U.S. Department of the Interior BUREAU OF LAND MANAGEMENT

Well Name: CORRAL 16-4 STATE FED Well Location: T25S / R29E / SEC 16 / County or Parish/State:

**Sundry ID: 2722700**

Type of Action: APD Change

WELL LOCATION AND ACREAGE DEDICATION PLAT

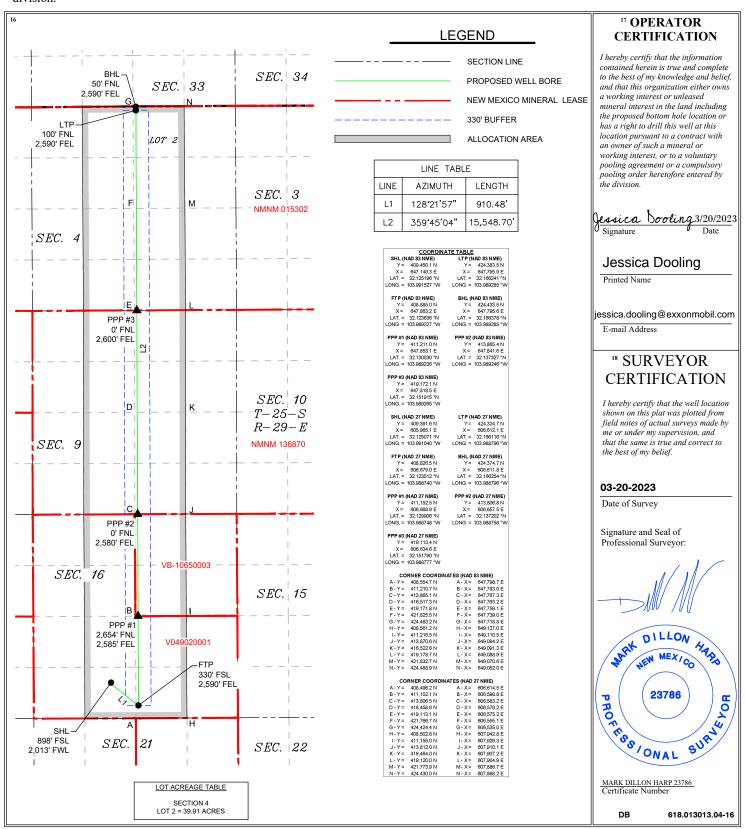
Procedure Description: \*\* Name Change, Pool Change, First and Last Take Point Changes, and Bottomhole Location Change XTO Energy LLC requests permission to make the following changes to the original APD: No Additional Surface Disturbance Change Well Name from Corral Canyon 16-4 State Fed Com to Corral 16-4 State Fed Com Change Pool from 98220 Purple Sage; Wolfcamp to 96217 Willow Lake; Bone Spring, Southeast SHL: No Change Change FTP: fr/330'FSL & 1590'FWL to 330'FSL & 2590'FEL, V049020001 (State Lease, No Lease Change) PPP1(WB002): to 2654' FNL & 2585' FEL VB-10650003 (State Lease) PPP2(WB003): to 0' FNL & 2580' FEL NMNM136870 (No Lease Change) PPP3(WB004): fr/ 330'FSL & 1590' FWL to 0' FNL & 2600' FEL NMNM015302 (No Lease Change) Change LTP: fr/330'FNL & 1590'FWL to 100'FNL & 2950'FEL, NMNM015302 (No Lease Change) Change BHL: fr/200'FNL & 1590'FWL to 50'FNL & 2590'FEL, NMNM015302 Section 4-T25S-R29E (No Lease Change) Casing/Cement design per the attached drilling program. Attachments: C102 Drilling Program Directional Plan

<sup>10</sup> Surface Location UL or lot no. Section Township Range Feet from the East/West line Ν 25 S 29 E SOUTH 2,013 **WEST EDDY** 16 898 "Bottom Hole Location If Different From Surface UL or lot no. East/West line Section Feet from the County Township Range Lot Idn Feet from the North/South line 4 25 S 29 E 50 **NORTH** 2,590 **EAST EDDY**
